# UNITED STATES PATENT AND TRADEMARK OFFICE

10/750,633

Arsen R. Hajian

## DETAILED ACTION

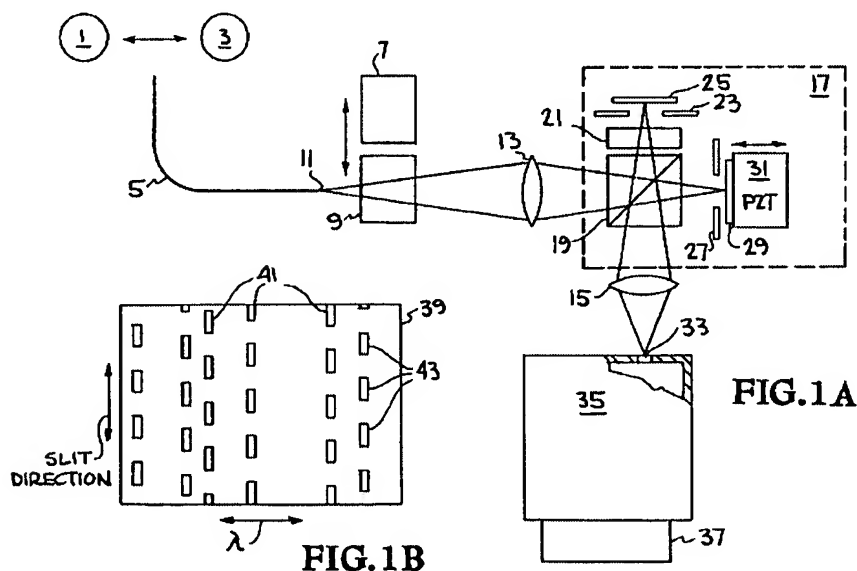
Claims 1-9 are rejected under 35 U.S.C. 102(b) as being clearly anticipated by Erskine(6,351,307).

With regard to claim 1, Erskine teaches a dispersing Fourier Transform interferometer, comprising:

a Fourier Transform Spectrometer having an input for receiving a source light and an output(17); and

a dispersive element having an input coupled to the Fourier Transform Spectrometer output and an output for providing the resulting multiple narrowband interferogram outputs of different wavelengths representative of the source light input(35).

As to claim 2, comprising a metrology system for determining optical path lengths internal to the interferometer(31, column 11, lines 37-38).

a sensor including a plurality of light intensity sensing elements each separately responsive to said different wavelengths for producing a set of data of interferogram intensities  $I_d$  measured at a set of discrete lags  $x_i$ (37); and

a processor for receiving and processing the data to produce a spectral output having a best fit with the set of data(column 12, lines 60-67; the processing element which maps the spectrum). While Erskine never mentions how the spectrum is mapped, clearly some processing computer must be inherent to the system to save the calibration data and determine the mapped spectrum.

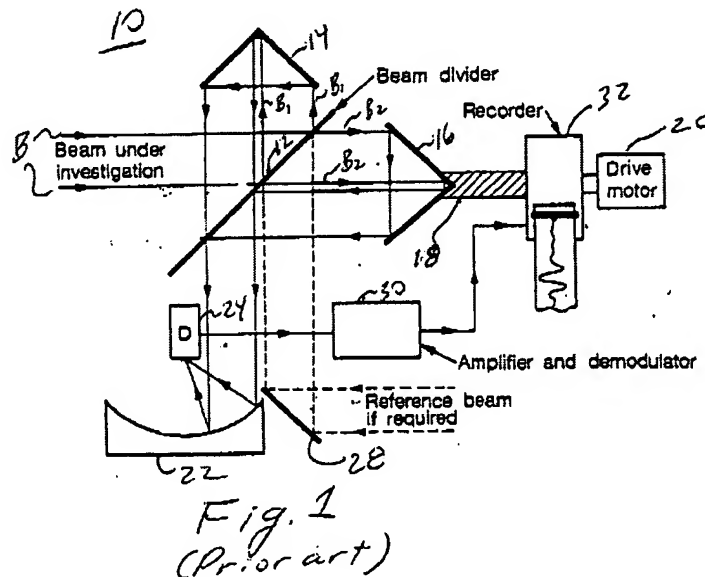
Claims 10-28, and 33-35 are rejected under 35 U.S.C. 103(a) as being unpatentable over Erskine(6,351,307) in view of applicant's prior art figure 1.

It would have been obvious to one of ordinary skill in the art at the time the invention was made to modify the Erskine apparatus by replacing the Michelson interferometer 17 with the Michelson interferometer 10 of applicant's prior art figure 1. While both are Michelson interferometers, applicant's figure 1 prior art includes a separate monochromatic reference beam which interferometrically

measures the displacement of the scanning mirror 16. This would have been superior to the Michelson interferometer of Erskine which determines the optical path difference by the current which drive the PZT actuator 31.

optics for receiving and collimating a source light along a first optical path(not shown, see collimated input light beam in figure 1);

a beamsplitter positioned for splitting the collimated source light into a second light beam along a second optical path differing from said first optical path(12);

a first reflector positioned along said first optical path for reflecting light transmitted through said beamsplitter back toward a beamsplitter(14);

a second reflector positioned along said second optical path for reflecting said second light beam back toward a beamsplitter(16); and
